**PUD &
SUBDIVISION STAFF REPORT****Date: June 3, 2004**

<u>DEVELOPMENT NAME</u>	Coastal Builder Subdivision	
<u>SUBDIVISION NAME</u>	Coastal Builder Subdivision	
<u>LOCATION</u>	54 & 56 Midtown Park West (West side of Midtown Park West, 700'± South of Dauphin Street)	
<u>CITY COUNCIL DISTRICT</u>	District 5	
<u>PRESENT ZONING</u>	B-3, Community Business	
<u>AREA OF PROPERTY</u>	1.0± Acre	1 Lot
<u>CONTEMPLATED USE</u>	Multiple Buildings on a Single Building Site with Shared Parking and Access.	
<u>TIME SCHEDULE</u>	Immediate	
<u>ENGINEERING COMMENTS</u>	Must comply with all stormwater and flood control ordinances. Any work performed in the right of way will require a right of way permit.	
<u>TRAFFIC ENGINEERING COMMENTS</u>	Driveway number, sizes, location and design to be approved by Traffic Engineering and conform to AASHTO standards. Widen driveway to twenty-four feet. Eliminate parallel parking to accommodate twenty-four foot aisle width and two-way traffic flows

SITE PLAN

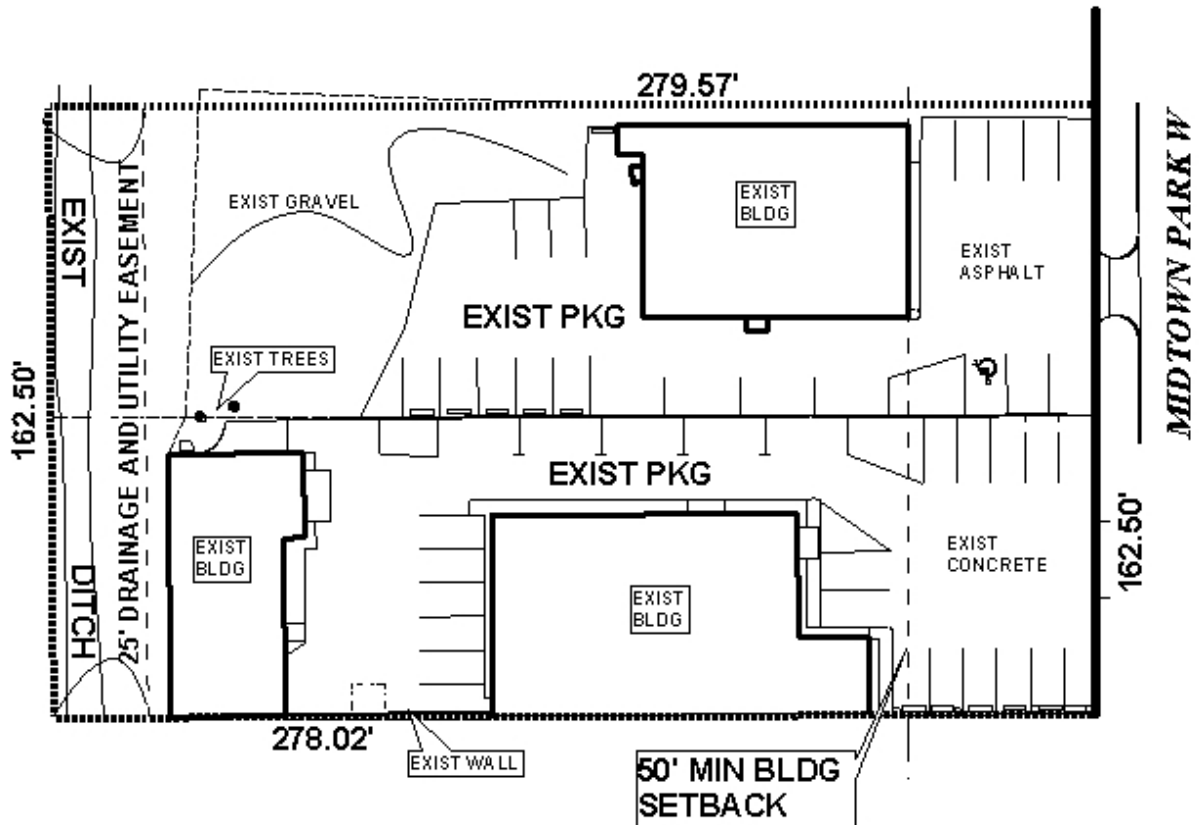
The site is a double-fronting property, with frontage on Midtown Park West and Springdale Boulevard. However, there is a significant drainage ditch located in a drainage easement along the rear of the site, adjacent to Springdale Boulevard. Therefore, a condition denying access to Springdale Boulevard would be appropriate.

Subdivision: the plat meets the minimum requirements of the Subdivision Regulations and is recommended for Tentative Approval subject to the following condition: 1) placement of a note on the final plat stating that there shall be no curb cuts to Springdale Boulevard.
